Groundwater Transfer Review Summary Form

Transfer/PA # T- 13434

Application: T-13434

Applicant Name: Big Hill LLC

Theis Time-Drawdown Worksheet v3.00

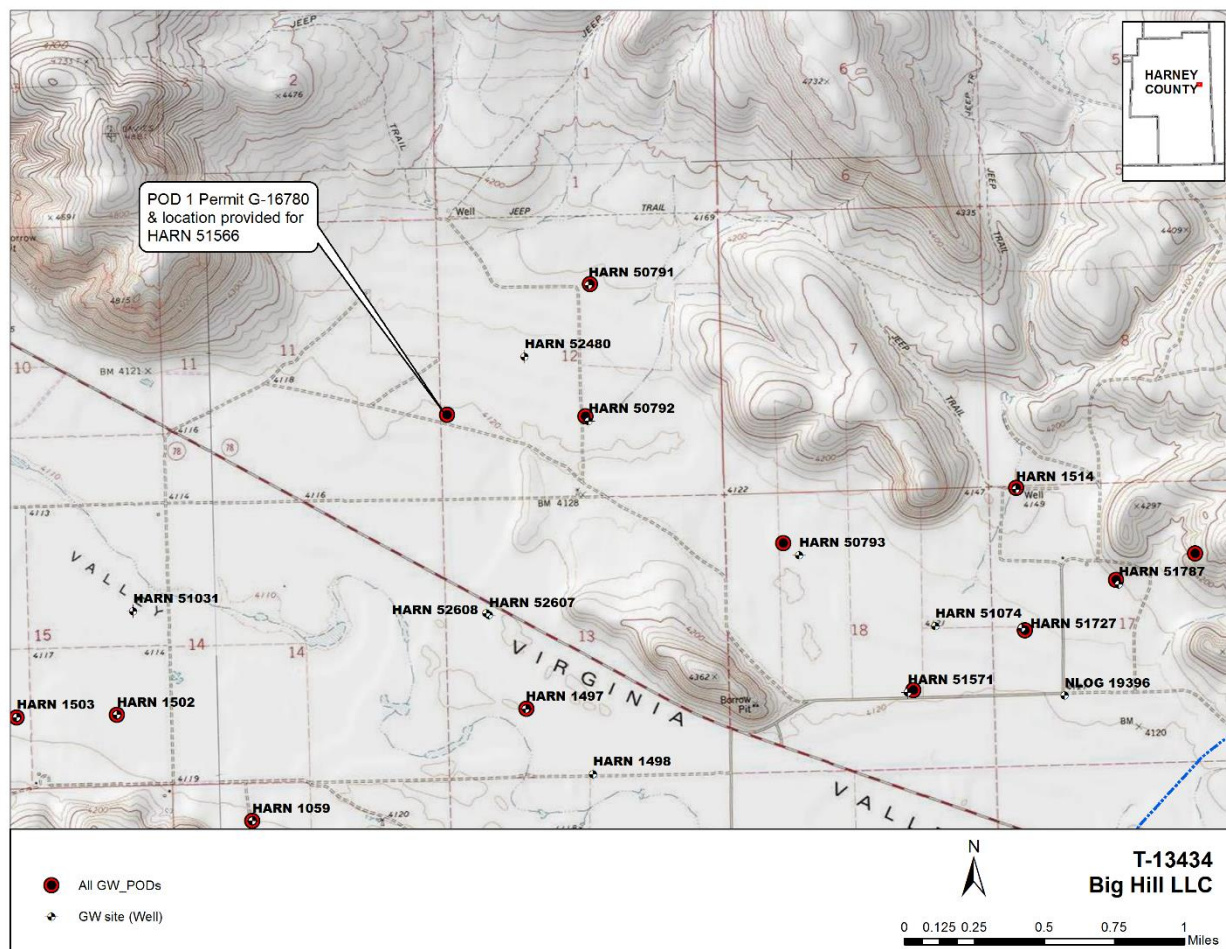
The potential increase in drawdown for these two wells was calculated using the Theis equation (see attachments). The values used for the calculation are conservative and appropriate until better values become available. The calculation used an intermediate storage coefficient (0.001). The transmissivity used in the calculation (28,000 ft²/day) is the median value of T estimates available for the Voltage Basalt. At the pro-rated pumping rate of the full duty over the full irrigation season (0.99 cfs), the results show a total drawdown of ~2 feet at the closest well; which should be within the capacity of the nearby wells. Note that the actual *increase* in interference over that already authorized from POD 1 is calculated to be less than this.
